On models 107 and 126 with 8-cylinder engine a new control unit with coding plug will be installed starting approx. 1/87. The 6-cylinder models will be phased in.

## 54-565 R and R control module

N4 Control unit cruise control/Tempomat without coding plug

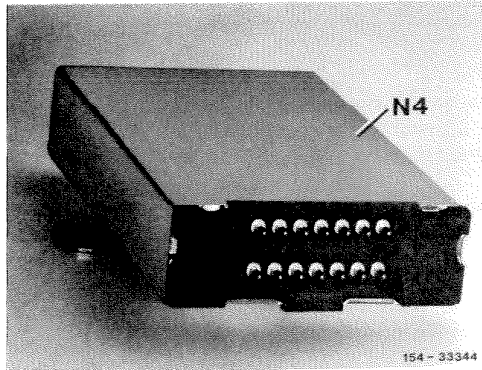
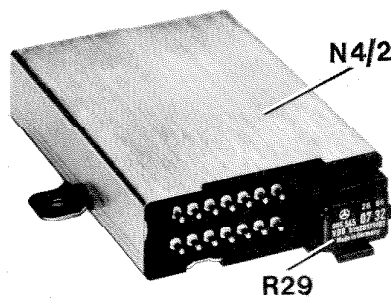
After using up spare parts stocks, only the new control unit and the respective coding plug will be available.

The new control unit with coding plug has no influence on cable lines and thereby also on wiring diagrams. Installation can proceed without changing harness.

N4/2 Control unit, cruise control/Tempomat  
R 29 Coding plug, cruise control/Tempomat
